ADDENDUM #001

Date: 6/4/2026

Blair Community Schools
Arbor Park Elementary School
Addition and Renovation
1717 Adams Street, Blair, Nebraska 68008

JJA Project: 3670
Drawings & Specifications
Dated: 5/18/2026

3 LEVEL ONE LIGHTING PLAN
E1.1 3/16" = 1'-0"

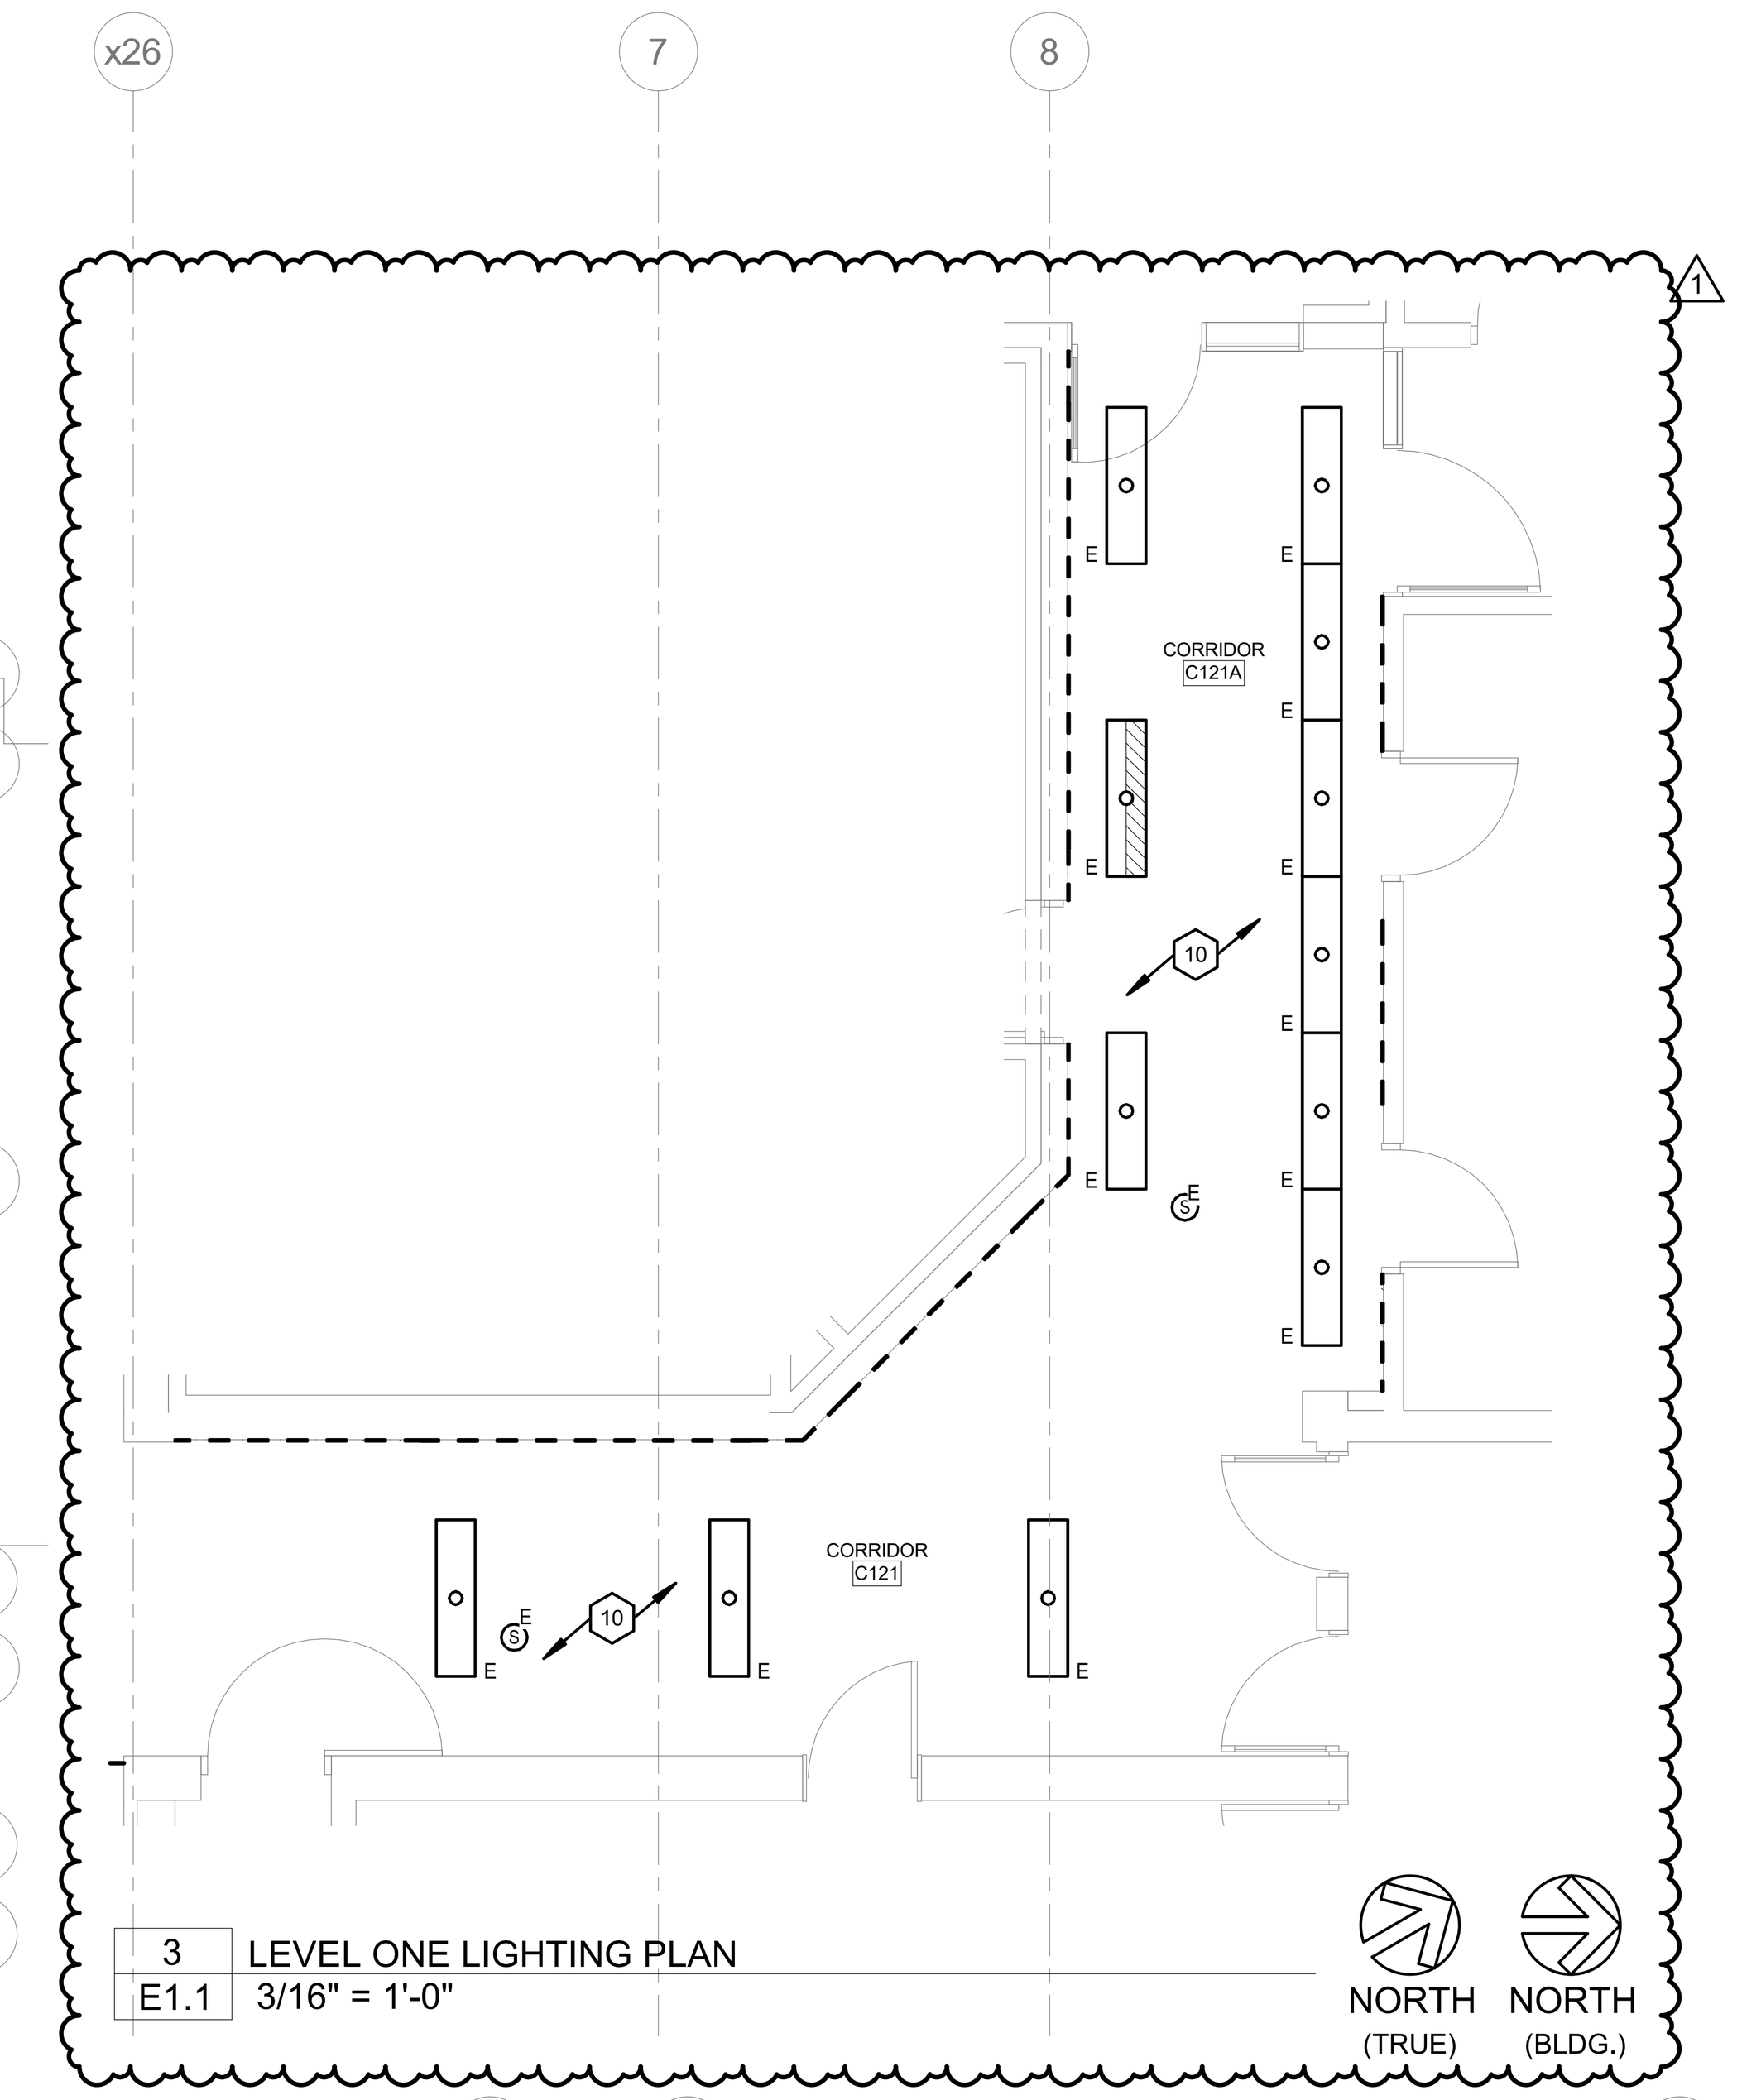
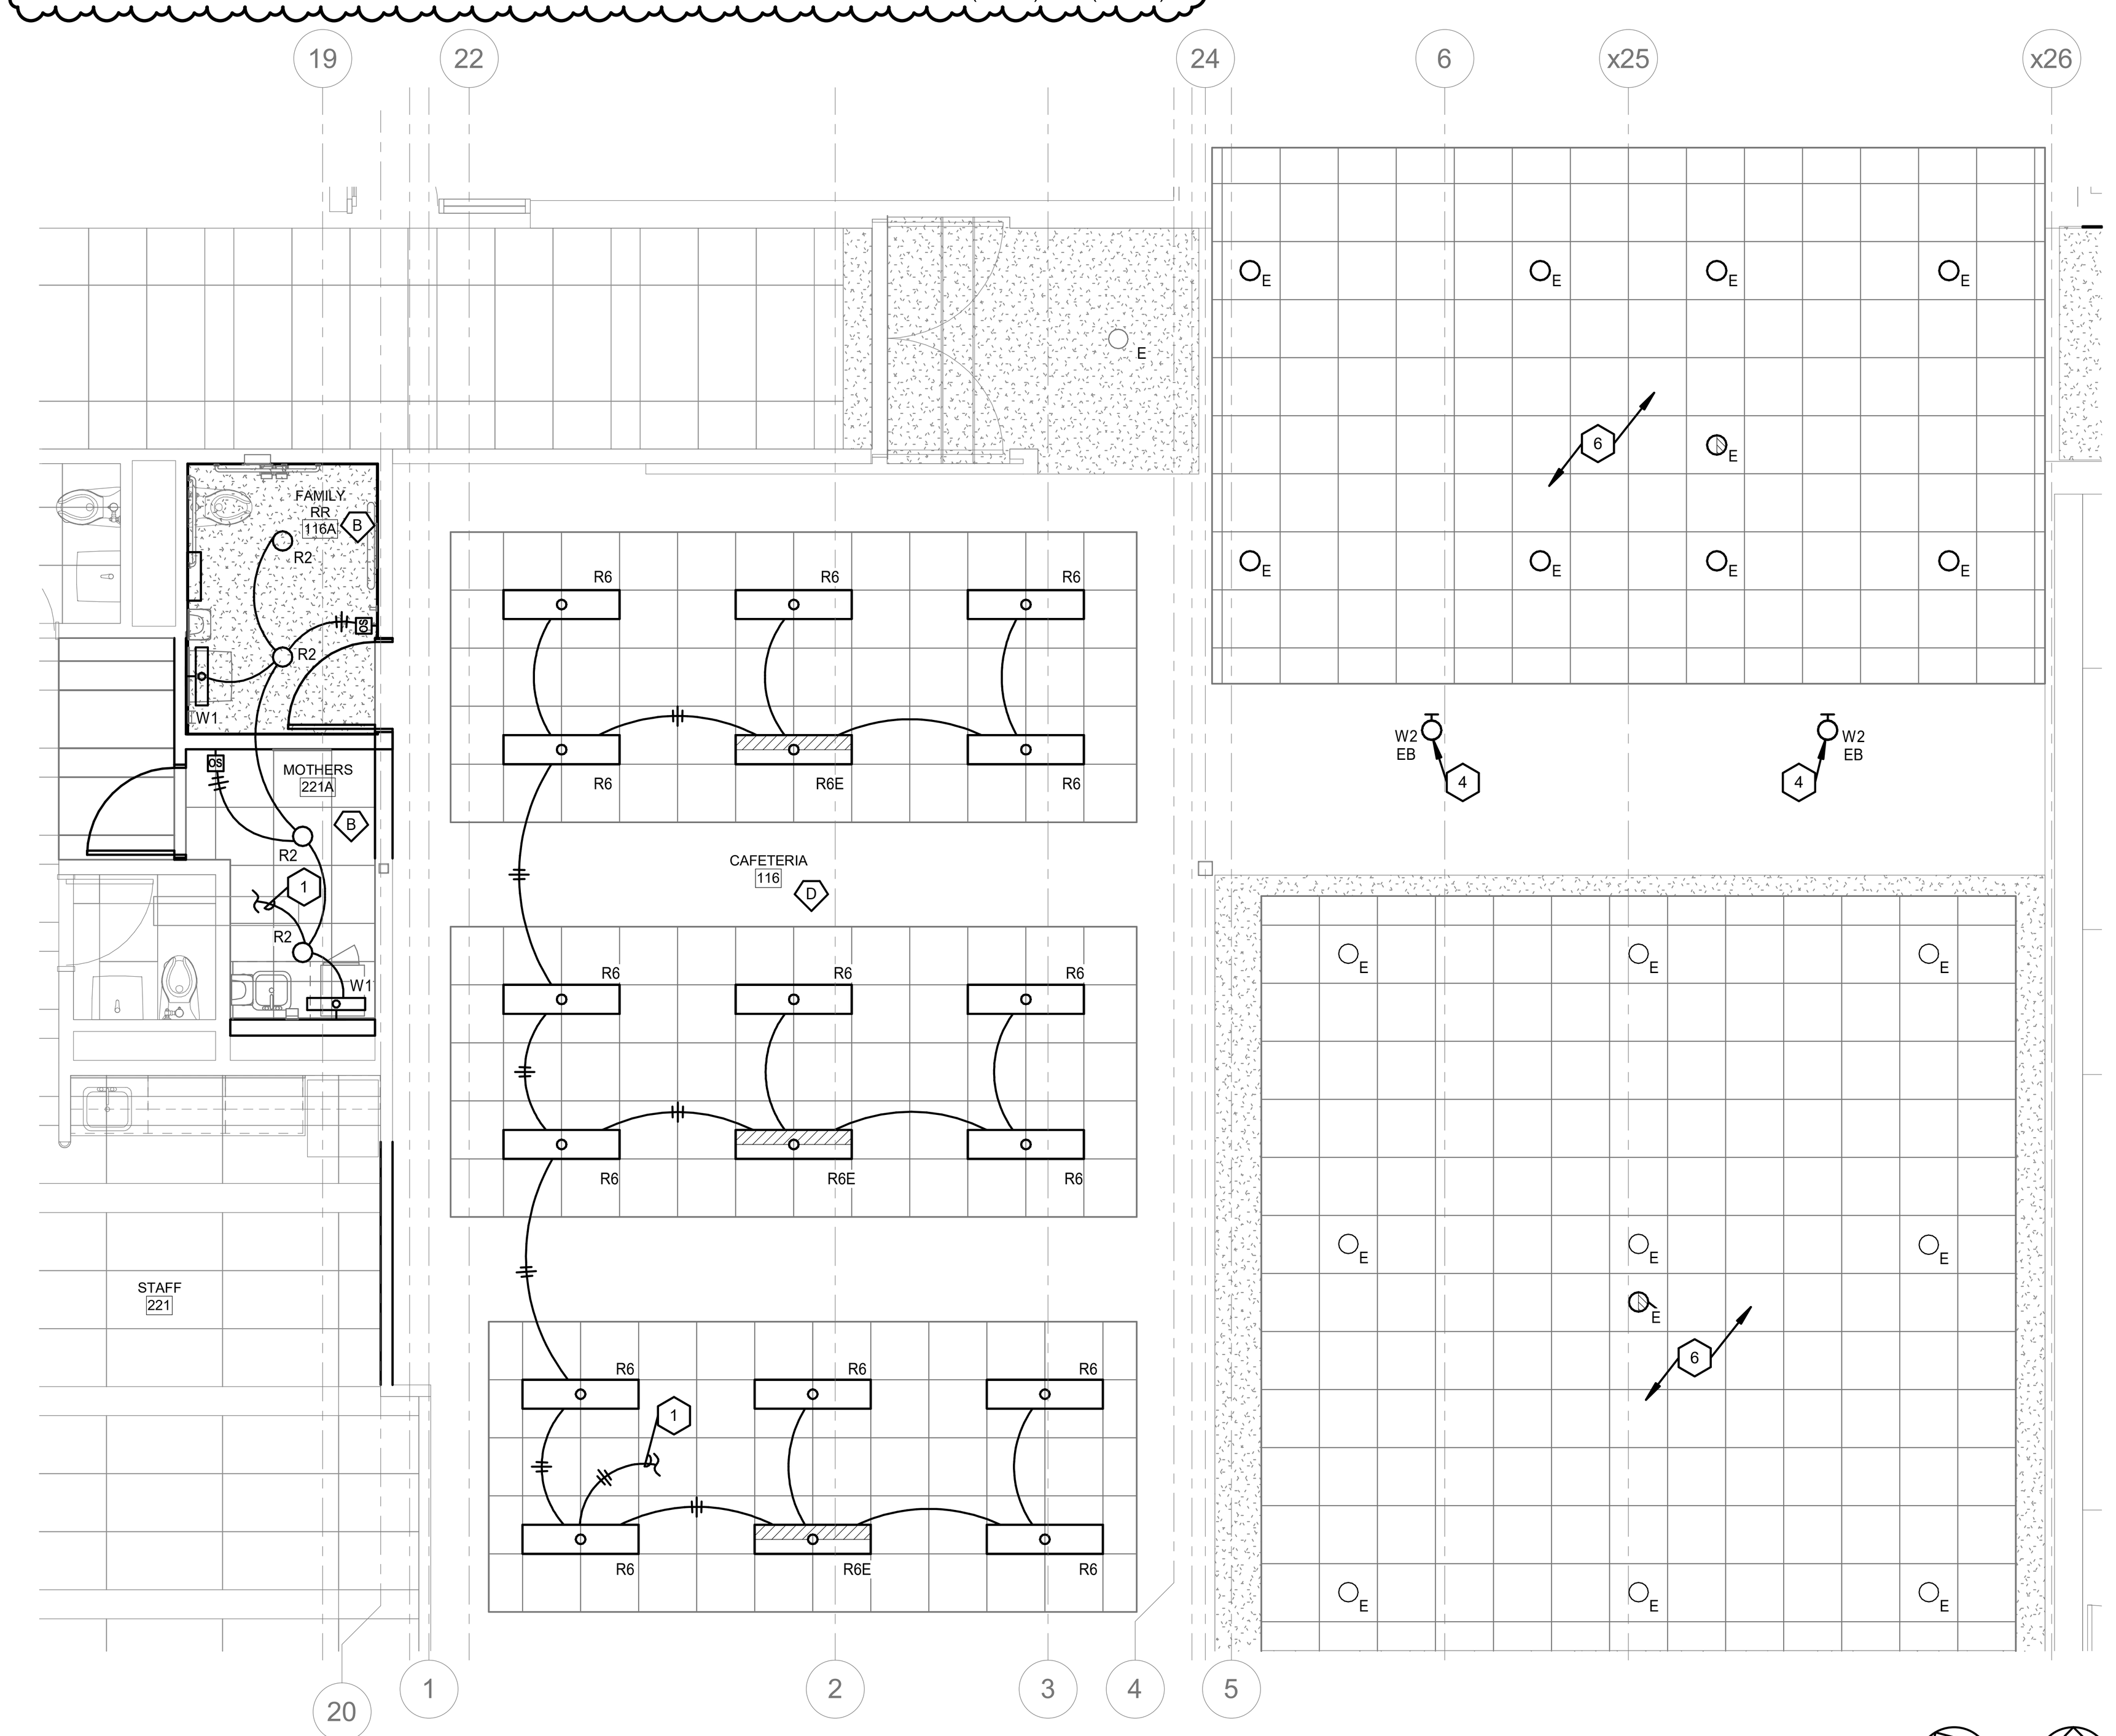
Item $45 Refer to Drawing E1.1 Level One Lighting Plan and the attached revised drawing sheet.
A. Add Floor plan for Corridor Lighting, see attached Sheet.

1	LEVEL ONE CAMERA PLAN
E3.2	1/16" = 1'-0"

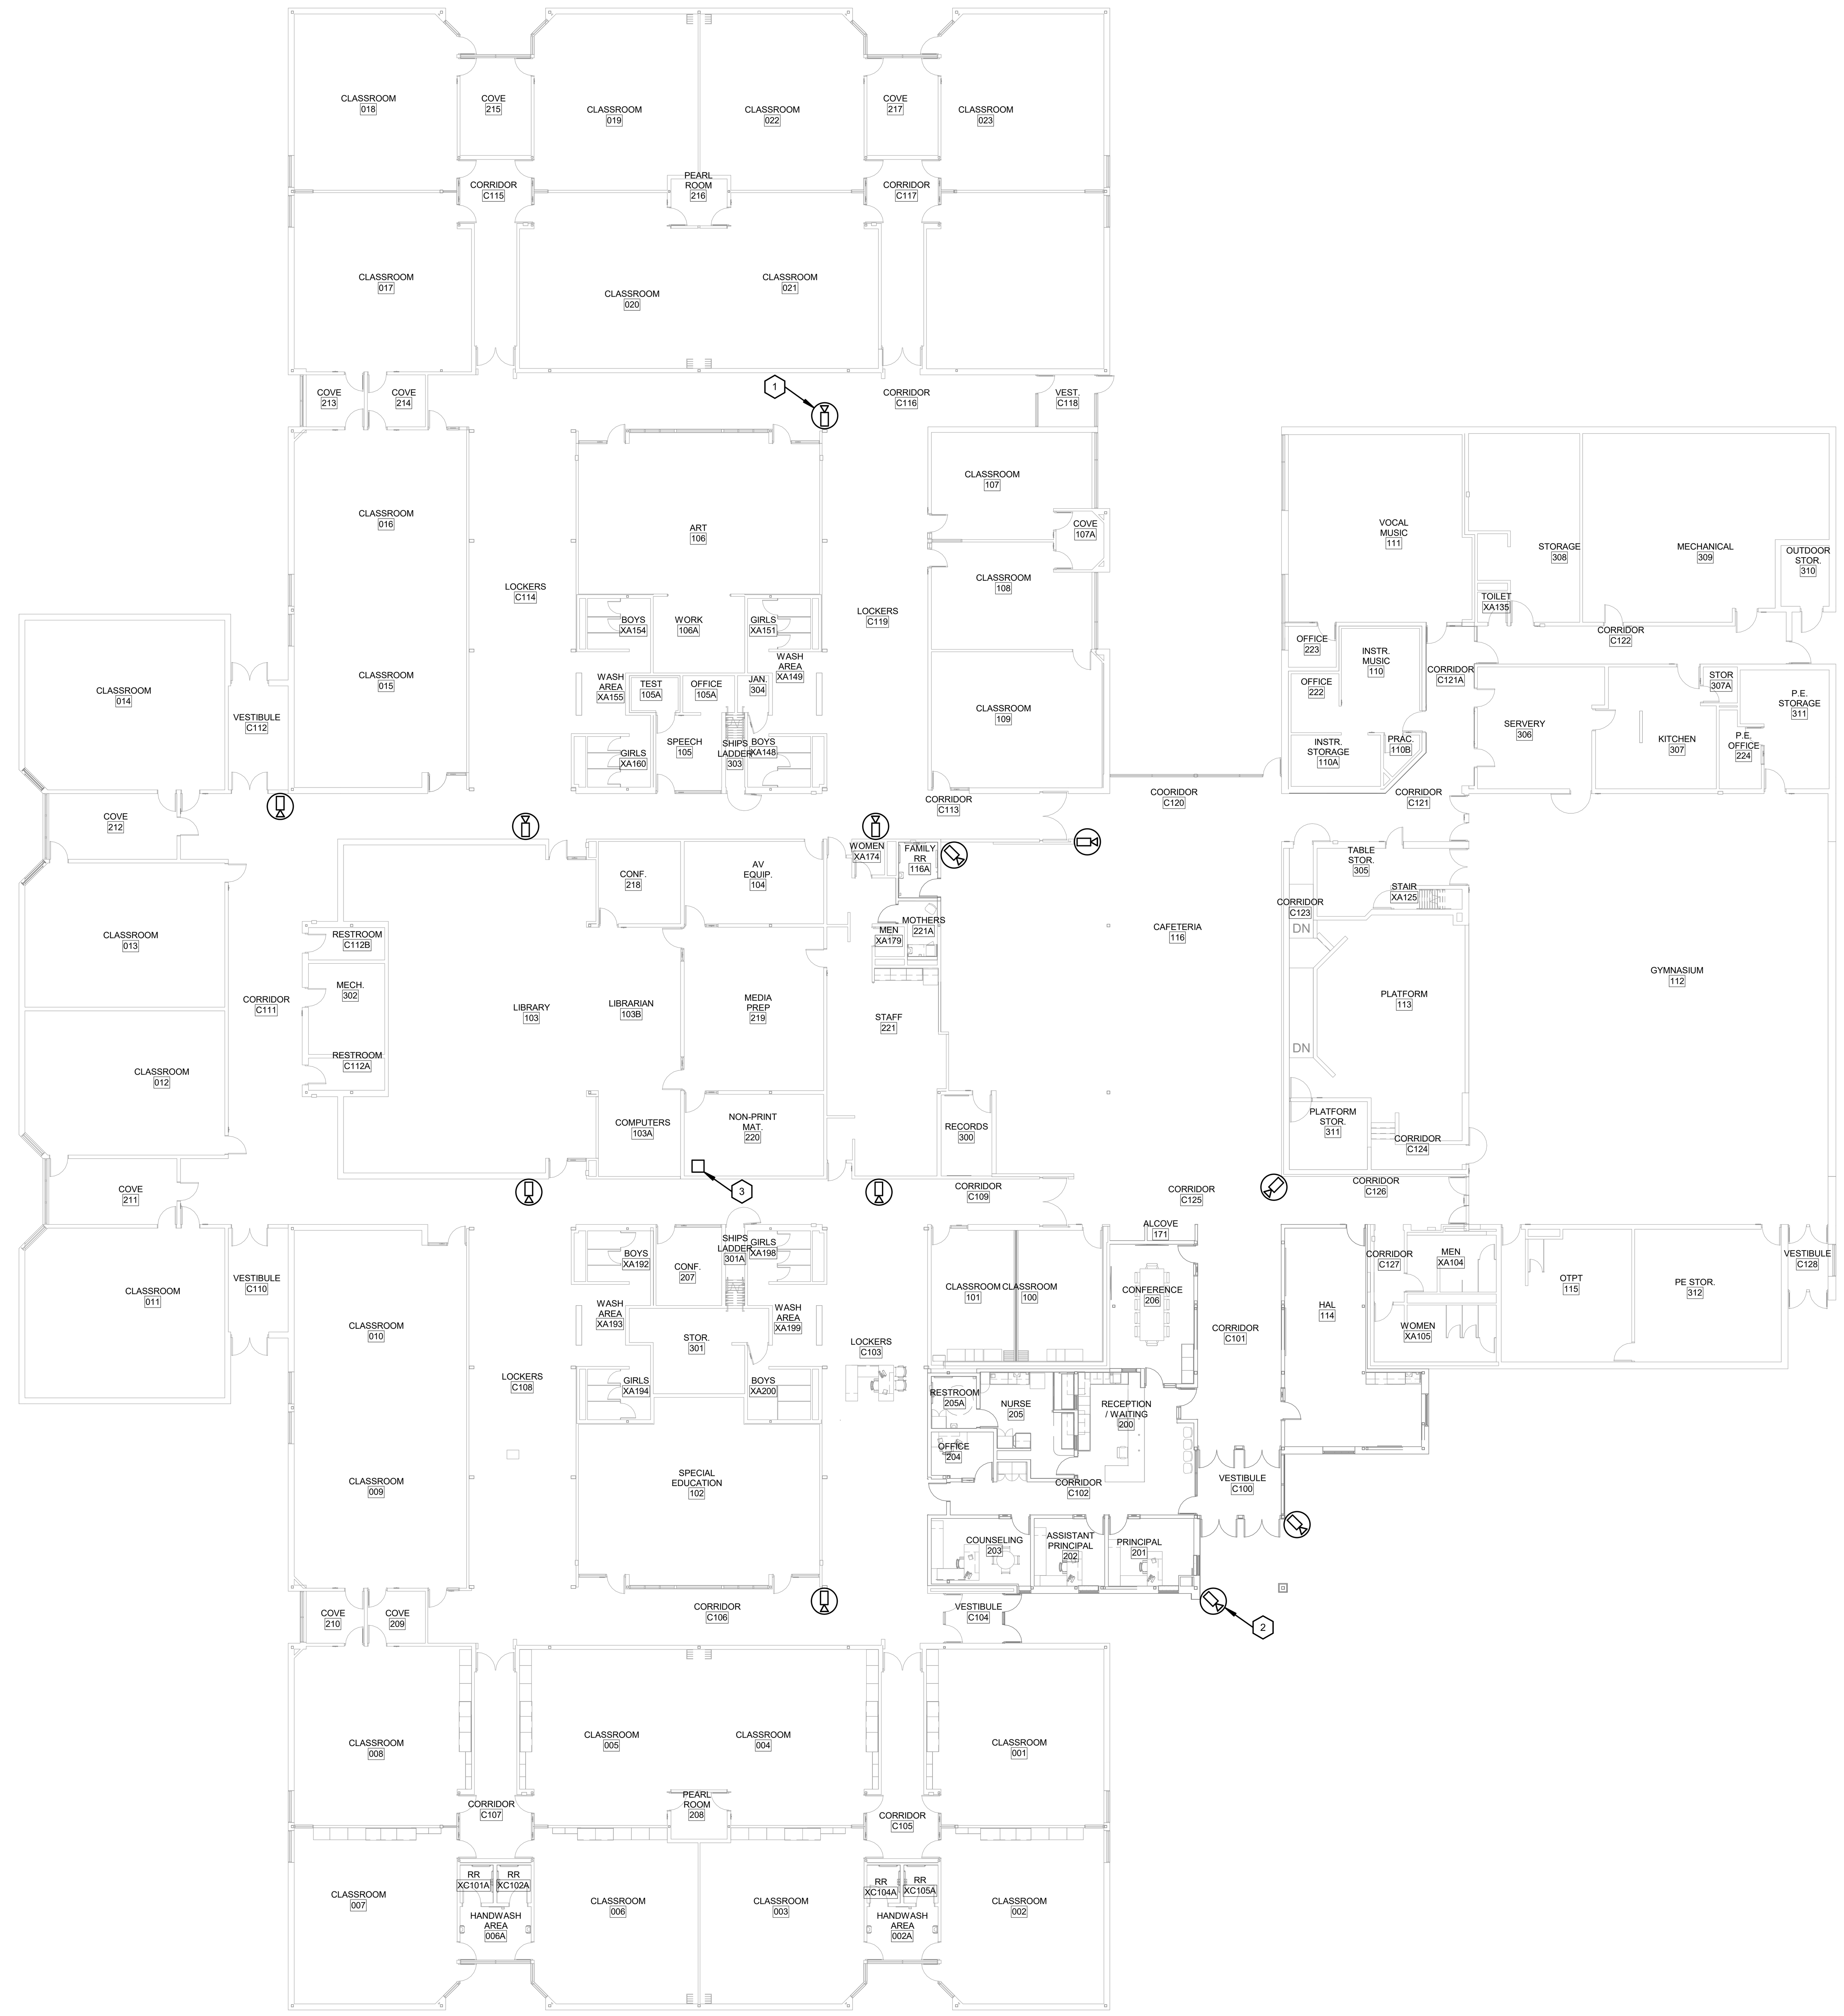
Item #47 Refer to new Sheet E3.2 Level One Technology Overall Plan and the attached drawing sheet.
A. Level One Camera Locations, see attached Sheet.
